CITY PLAN COMMISSION**THURSDAY, MARCH 20, 2025****FILE NUMBER:** S245-109**SENIOR PLANNER:** Sharmila Shrestha**LOCATION:** SMU Boulevard at Prentice Street, northwest corner**DATE FILED:** February 19, 2025**ZONING:** MU-3**CITY COUNCIL DISTRICT:** 9**SIZE OF REQUEST:** 2.2745-acres**APPLICANT/OWNER:** Southern Methodist University, Peruna East Corporation

REQUEST: An application to replat a 2.2745-acre tract of land containing all of Lots 14A, 18 through 21 and part of Lots 22 and 23 in City Block D/5187 to create one lot on property located on SMU Boulevard at Prentice Street, northwest corner.

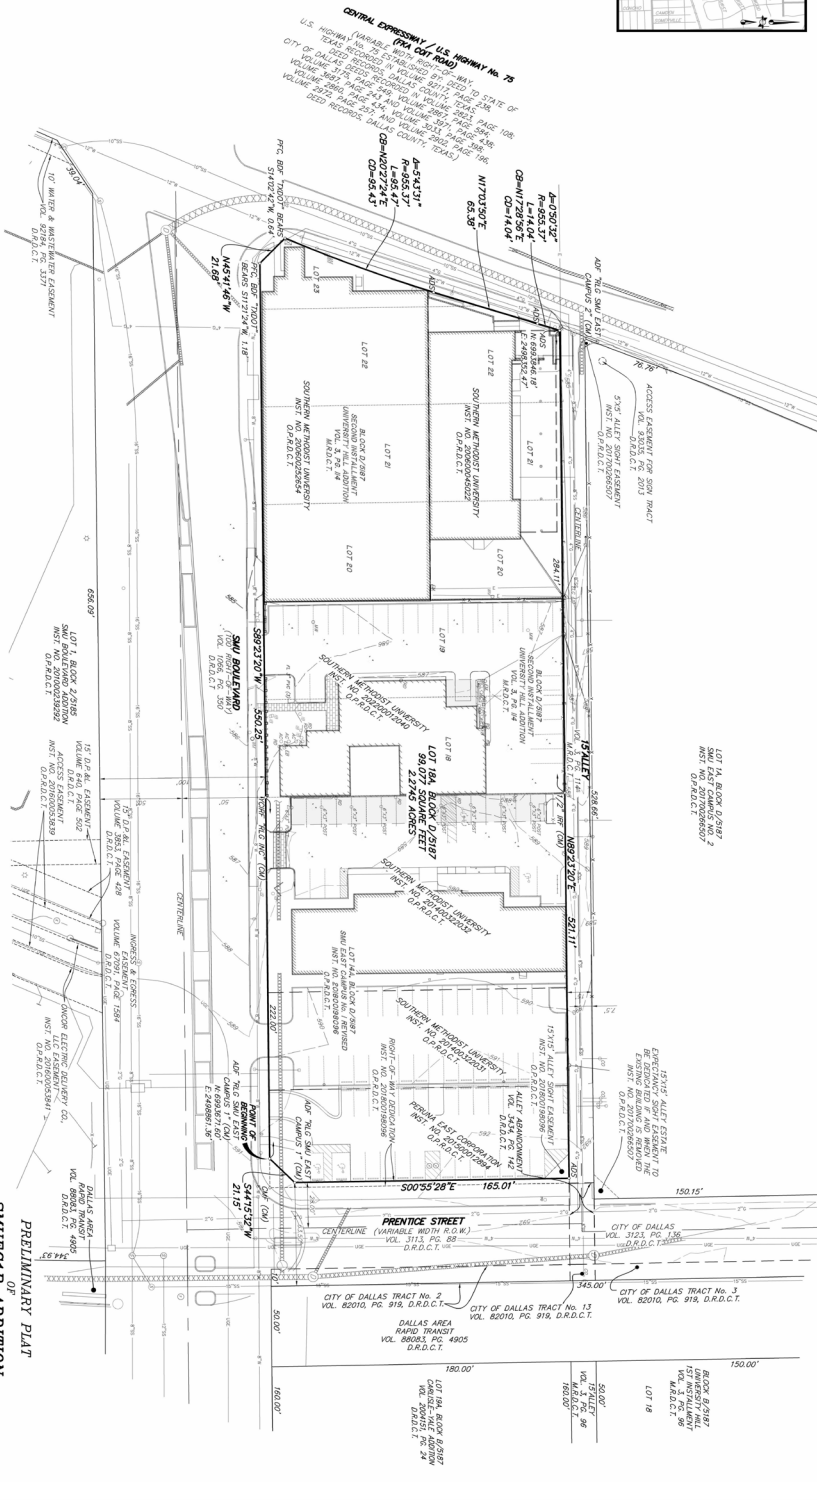
15. On the final plat, dedicate 50 feet of right-of-way (via fee simple) from the established center line of SMU Boulevard. *Section 51A 8.602(c)*
16. On the final plat, dedicate a 15-foot by 15-foot alley sight easement at the intersection of Central Expressway/ U.S. Highway No. 75 & the alley. *Section 51A-8.602(e)*
17. TXDOT approval may be required for any driveway modifications or new access.
18. Must coordinate with Transportation Department for any traffic signal requirements that are deemed necessary for improving pedestrian accessibility and safety related to site development (Contact Srinivasa Veeramallu with Traffic Signals). *51A-8.606, 51A-8.608*

19. On the final plat, dedicate a minimum 5-foot by 5-foot corner clip (via fee simple or street easement) at the intersection of SMU Boulevard and Central Expressway/ U.S. Highway No. 75. Section 51A 8.602(d)(1)

20. On the final plat, dedicate a minimum 5-foot by 5-foot corner clip (via fee simple or street easement) at the intersection of SMU Boulevard and Prentice Street. Section 51A 8.602(d)(1)

26. Prior to the final plat, provide a copy of the recorded quitclaim deed to Real Estate for Abandonment Ordinance No. 4988 and show the abandonment on the plat as: Abandonment authorized by Ordinance No. _____, recorded as Vol., Page Nos. (Cert. ORD No. _____, QCD No. _____). Utility Easements retained.
27. Prior to final plat, compliance with City's Street lighting standards including illumination standards, material, installation, and activation per Street Design Manual.
28. On the final plat, change "SMU Boulevard" to "SMU Boulevard (FKA Yale Boulevard FKA Silven Boulevard)".
29. On the final plat, identify the property as Lot 14B in City Block D/5187.
